Response to Comments on the Draft NPDES Permit for the City of Burley Industrial Wastewater Treatment Plant (IWTP)

**EPA Region 10
March 2009
NPDES Permit #ID-000066-3**

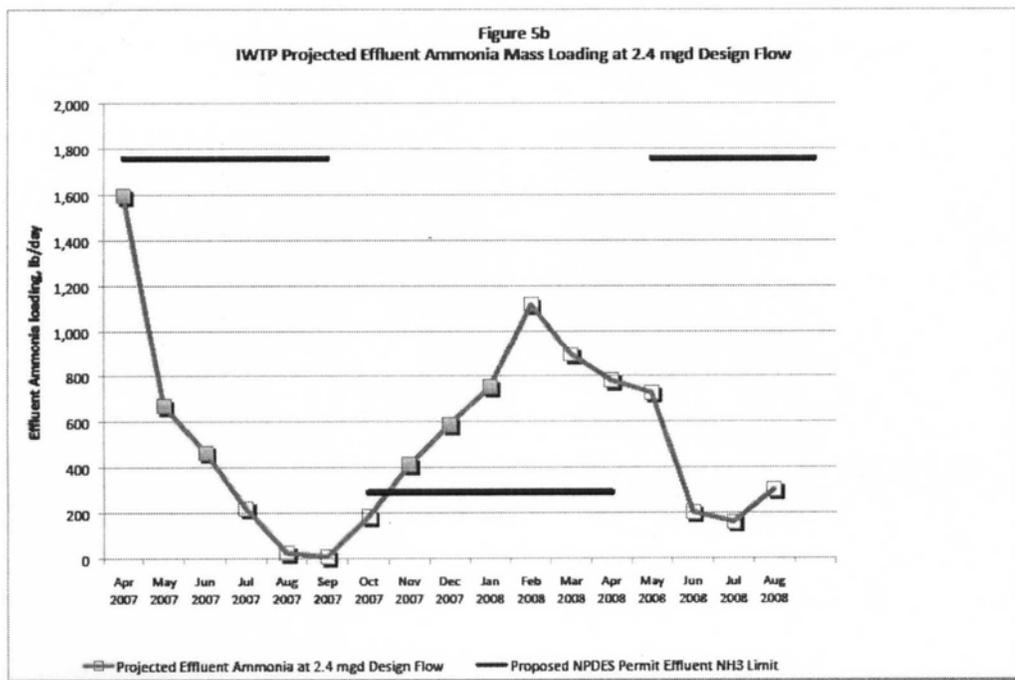
The City stated that the ammonia limits in the draft permit represent a significant and severe reduction relative to the effluent limits in the City's administratively extended permit and will place the City in consistent non-compliance from the date the proposed permit becomes effective. The City stated that warm water species are known to be less susceptible to ammonia

than cold water species. The City stated in its comments that it would like to understand the rationale for (the) more stringent ammonia limit between October and April.

The basis for the ammonia effluent limits in the permit is explained in detail in Appendix D to the 2008 fact sheet. The effluent limits are more stringent from October through April than they are from May through September because river flows tend to be much lower during the season of October through April than they are during the balance of the year, as shown in Table 1 of the 2008 fact sheet (Page 9). The calculation of ammonia effluent limits uses Idaho's ammonia criteria for waters designated for warm water aquatic life (IDAPA 58.01.02.250.04.d). These criteria are less stringent than the ammonia criteria applicable to waters designated for cold water aquatic life. Therefore, the derivation of the effluent limits considers the fact that warm water species are less sensitive to ammonia.

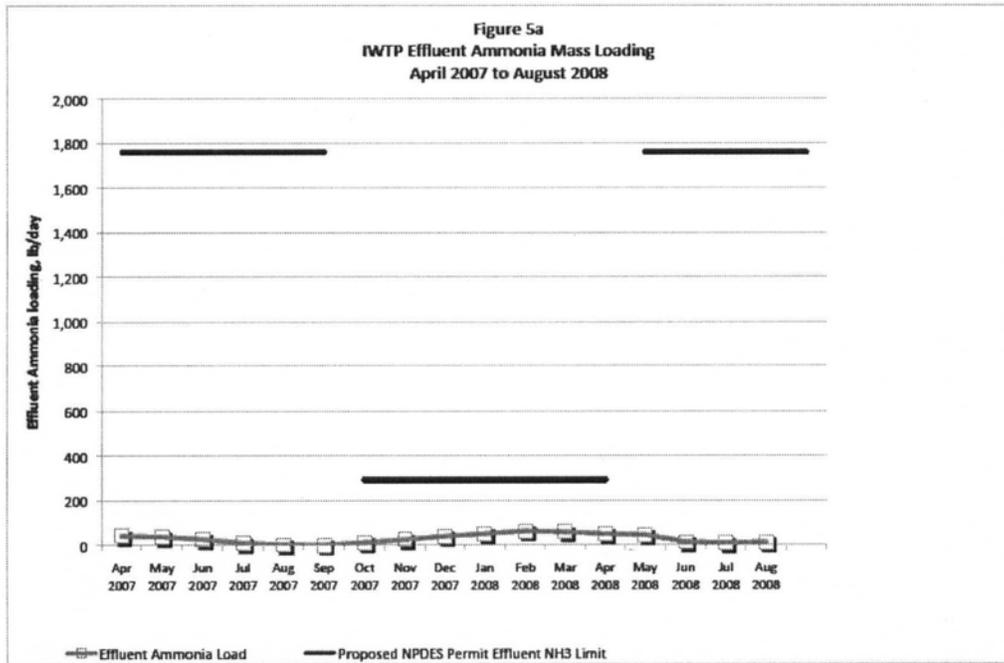
The City's statement that the revised ammonia limits will place the City in consistent non-compliance appears to be based on Figure 5b in its comment letter, which is reproduced below.

This figure extrapolates what the effluent ammonia loads would be, *if* the observed effluent concentrations were maintained and the effluent flow rate was increased to the design capacity of 2.4 mgd. If that were the case, the effluent ammonia loading would be much greater than that allowed by the October through April effluent limits. Figure 5a, on the other hand, shows the *actual* ammonia loads, which are consistently much less than all of the ammonia effluent limits (see below). As the City has noted elsewhere in its comments, current effluent flows are roughly 0.3 mgd, which partially explains why the effluent ammonia loads have been consistently below the proposed effluent limits.

In order to establish a schedule of compliance in a permit for a given effluent limit, the permitting authority must make a reasonable finding, supported by the administrative record, that the permittee cannot immediately comply with the effluent limit on the effective date of the final permit (*see* memorandum from James Hanlon, EPA Office of Wastewater Management to Alexis Strauss, EPA Region 9, May 10, 2007). If the permittee can immediately comply with an effluent limit on the effective date of the final permit, then no compliance schedule can require compliance “as soon as possible” (40 CFR 122.47(a)(1)). Based on Figure 5a in the City’s comment letter, the permittee can, in fact, comply with the ammonia effluent limits immediately on the effective date of the final permit. Therefore, no compliance schedule may be allowed for the ammonia effluent limits.

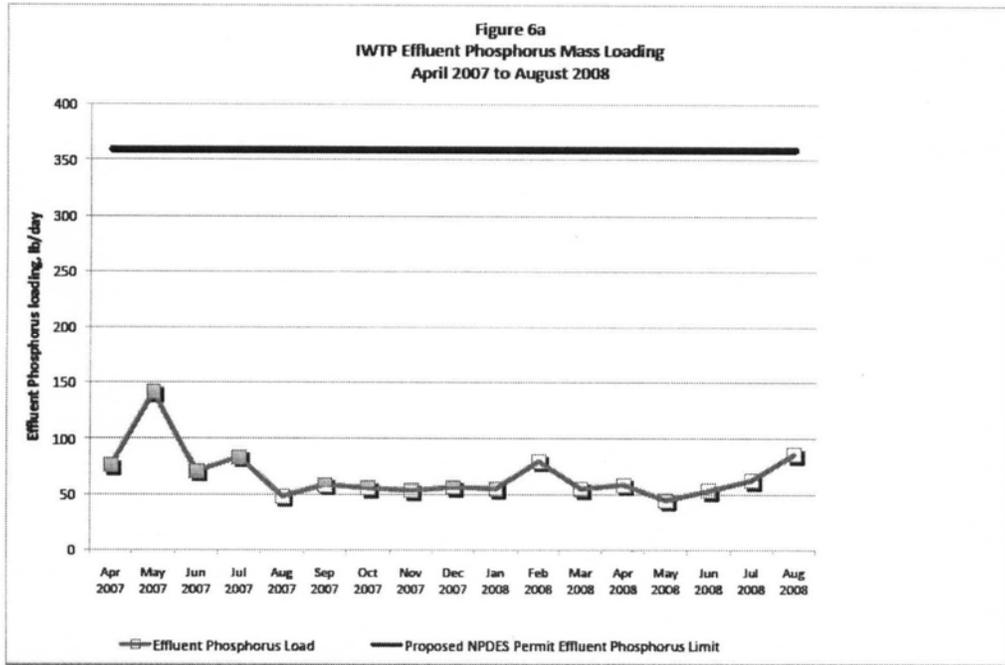
The City stated that the phosphorus limits in the draft permit represent more than a 20% reduction relative to the effluent limits in the City’s administratively extended permit. The City stated that, once effluent flow rates reach the design capacity of 2.4 mgd, the City will not be able to comply with the phosphorus effluent limits in the draft permit.

Similar to ammonia (*see* the response to Comment #4), EPA cannot establish a compliance schedule for phosphorus, because, based on Figure 6a in the permittee's comment letter (below), the permittee can comply with the phosphorus effluent limits immediately on the effective date of the final permit.
